DESIGN MEMORANDUM NO. 14

COOPER RIVER REDIVERSION PROJECT

FISH HATCHERY

SADEN-GP (11 Sep 80) 3rd Ind
SUBJECT: Cooper River Rediversion Project, Design Memorandum 14 -
Fish Hatchery

BY J C Y DATE 2-7-80 SUBJECT C.O.E. - S.C. SHEET NO 2 OF
 CHECKED BY DATE FISH HATCHERY JOB NO 90116-10
LAYOUT PLAN-ALT. NO. 2

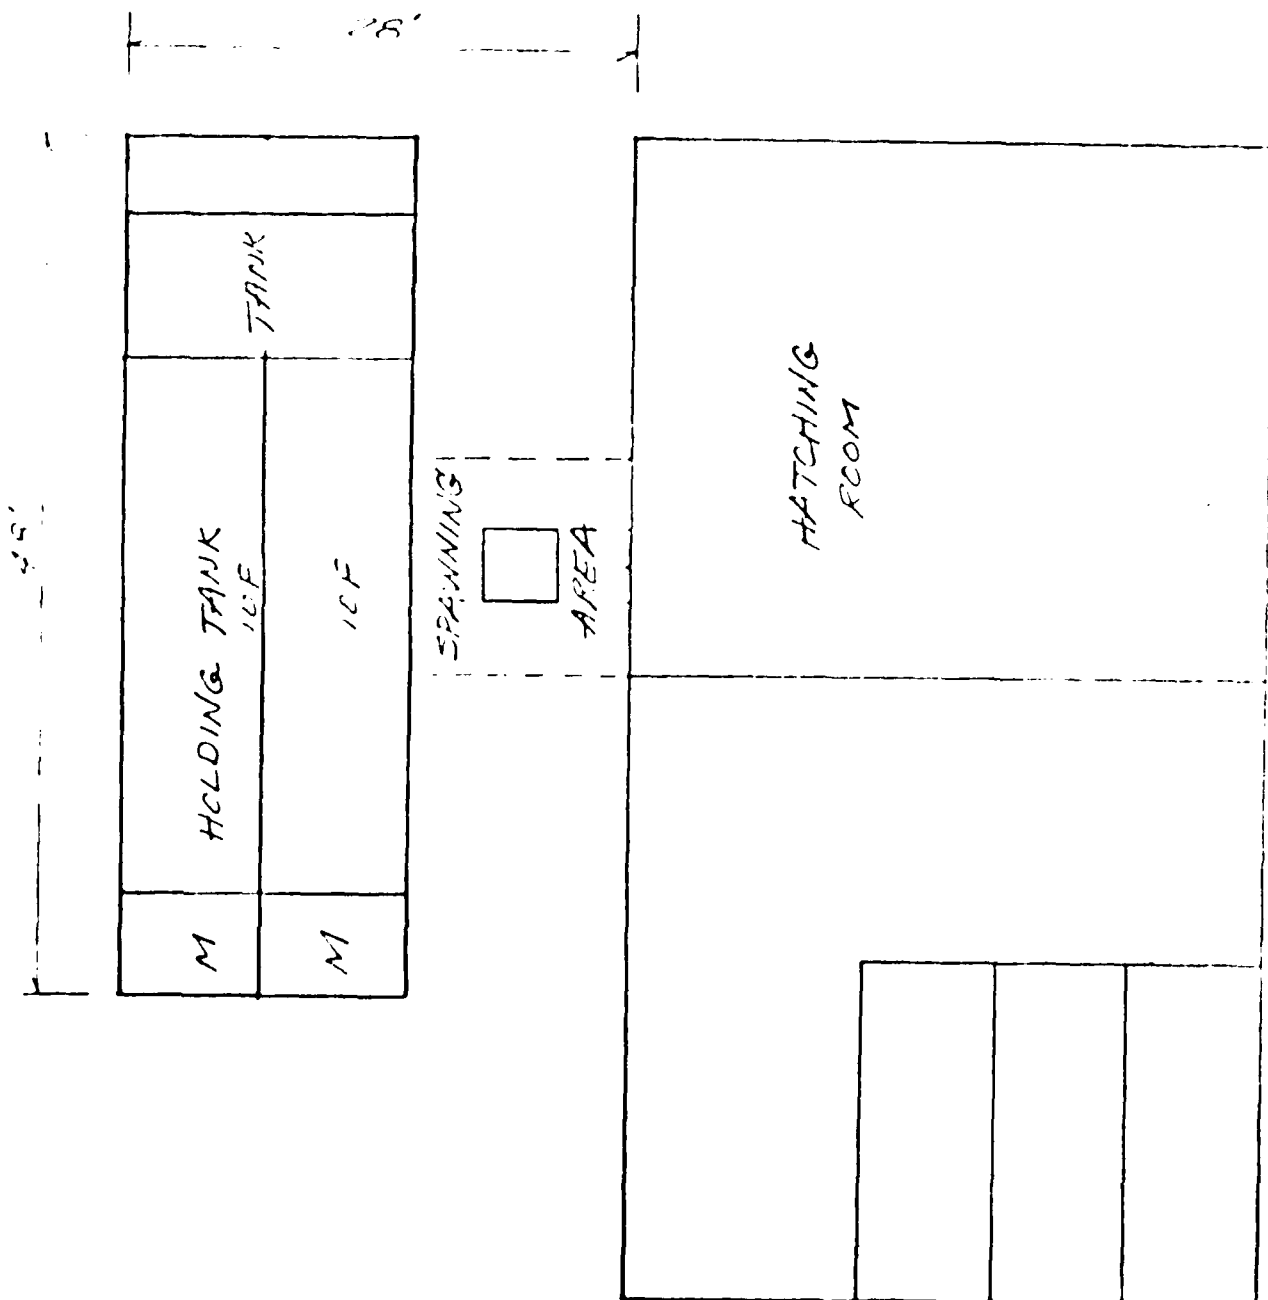
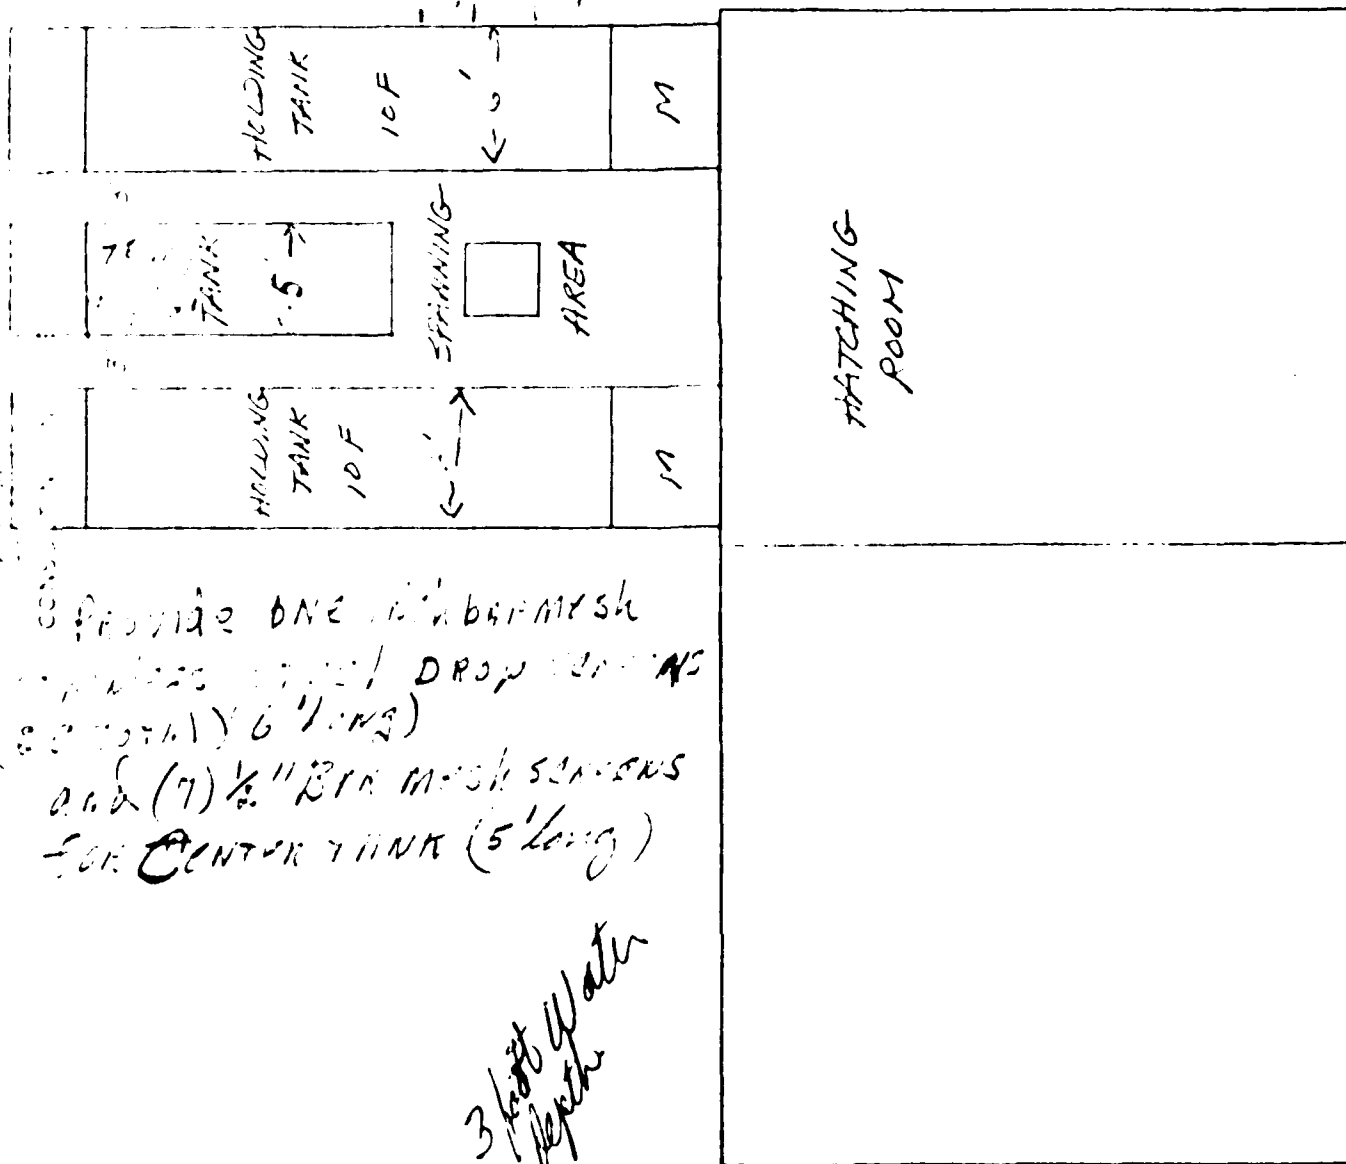
Attached please find copies of your suggested layout plan.
We prefer alternate number 2 and have made some suggestions
on the drawing which we feel will help the overall setup.

← NOTE: FENCE SET UP
7' ON 1 SIDE, 13' ON OTHER SIDE
THROUGH FENCE
